TAPS CODE ASSESSMENT – 289 WATERWORKS ROAD, ASHGROVE QLD

STEP Advisory has been engaged to undertake a TAPS code assessment of the proposed residential development at 289 Waterworks Road

The particular requirements for the Transport, Access, Parking and Servicing Code identified by Brisbane City Council in a RFI dated 05 July 2025 are shown below.

Figure 1 Site Layout showing four (4) spaces

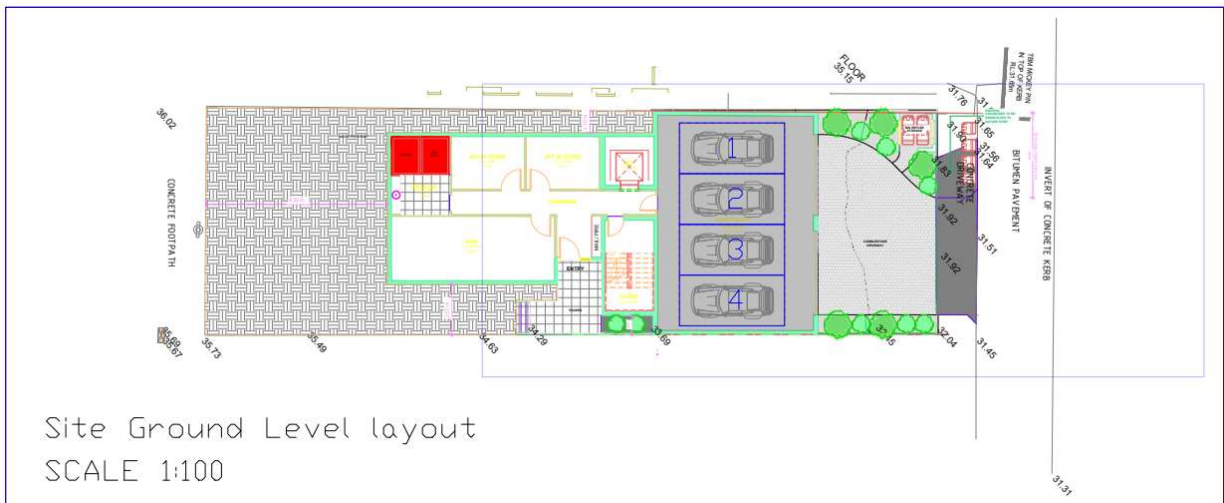
a) Provide a minimum of 4 resident car parking spaces.

Plans as provided by UXD and reviewed by STEP Advisory, as shown below and as per Attachment A, show that four (4) resident car parking spaces are provided.

Figure 3 Pedestrian Sight Distances

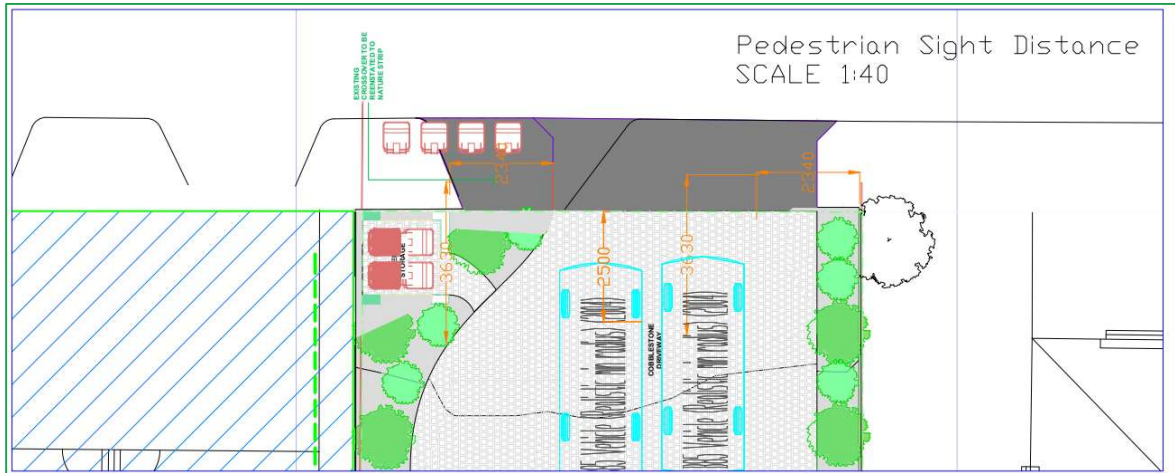
AO9.3 Development ensures that sight distances to and from all proposed access driveways...

- Further, the sight distances have been measured and are sufficient as shown in the following figure, based on the worst movement (reversing from car space 4) with
 - Pedestrian visibility at 2.5 metres behind the property boundary and 2.0 metres inside the property boundary as shown below.

Figure 5 Driveway Dimensions

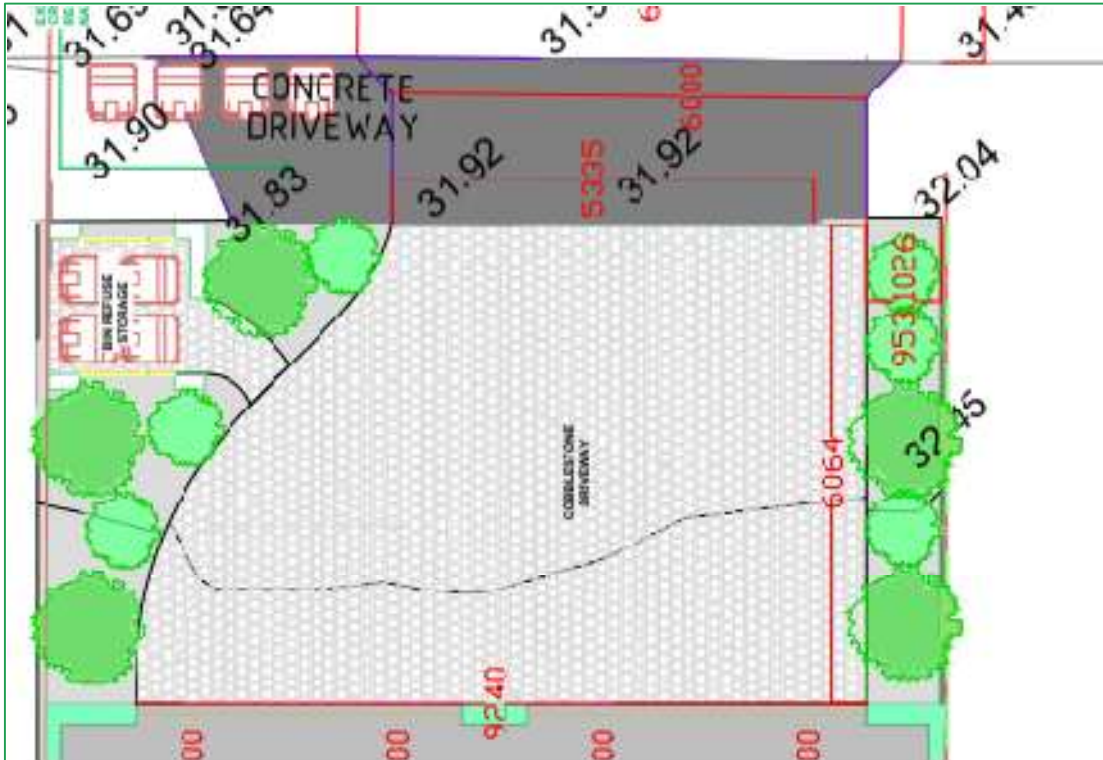
AO9.4 Development provides access driveways in the road area which...

- The driveway for the site is in accordance with the provisions of the TAPSP with dimensions as shown below and as attached.

Figure 6 B85 Swept Path

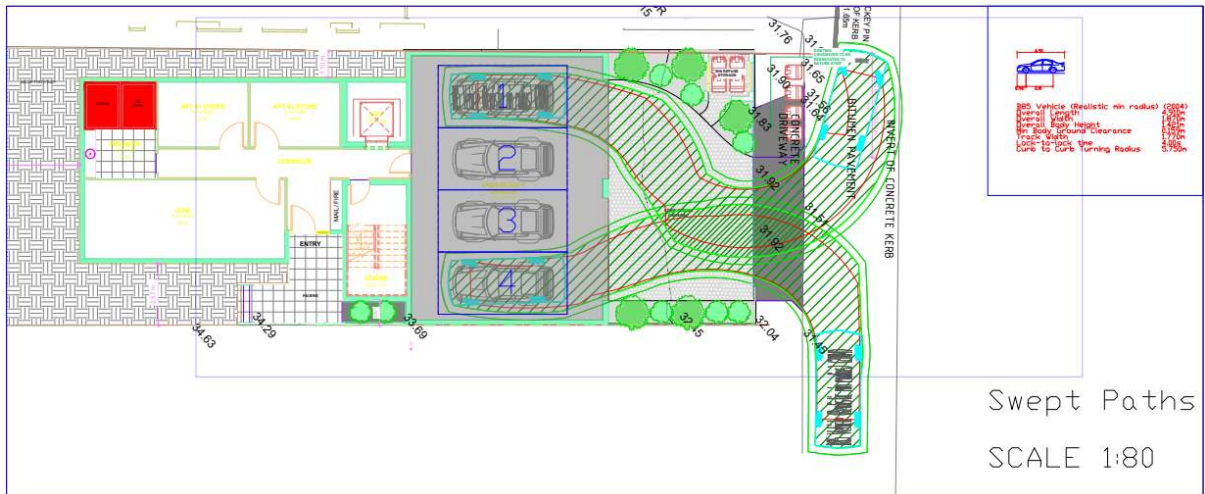
AO15 Development provides parking bays, queue areas and manoeuvring...

- Swept paths for a B85 entering the site in a forward direction along Wessex Lane from the east and arriving at space 4 (tightest entry) and exiting the site in a forward direction to Wessex Lane towards the west and leaving from space 1 (tightest exit) are provided below and in the attachment.

Figure 8 Dimensions

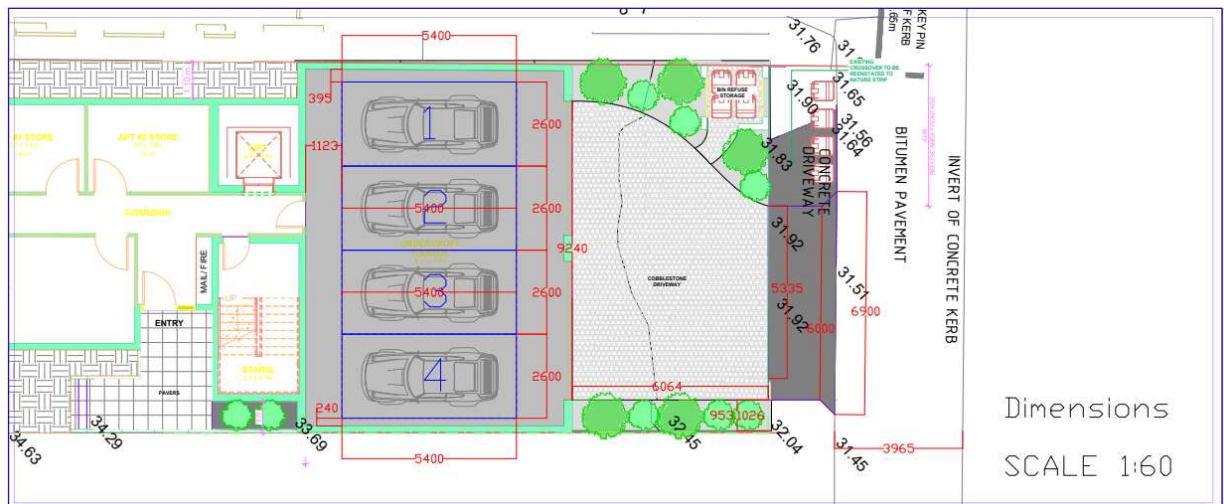
c) Provide a Concept plan that includes proposed access, car parking space arrangements and clearances, ensure that all are clearly dimensioned.

7.8.2 (1) – All angled spaces are to be not less than 5.4 metres long.

- All spaces are 5.4 metres long.

Table 18 – Class 3 – Reserved spaces where passengers and goods are loaded or unloaded, such as tenant car parking area in a residential complex – minimum width of space is to be 2.6 metres.

- All spaces are 2.4 metres wide.

A concept plan showing all dimensions is shown below and attached.
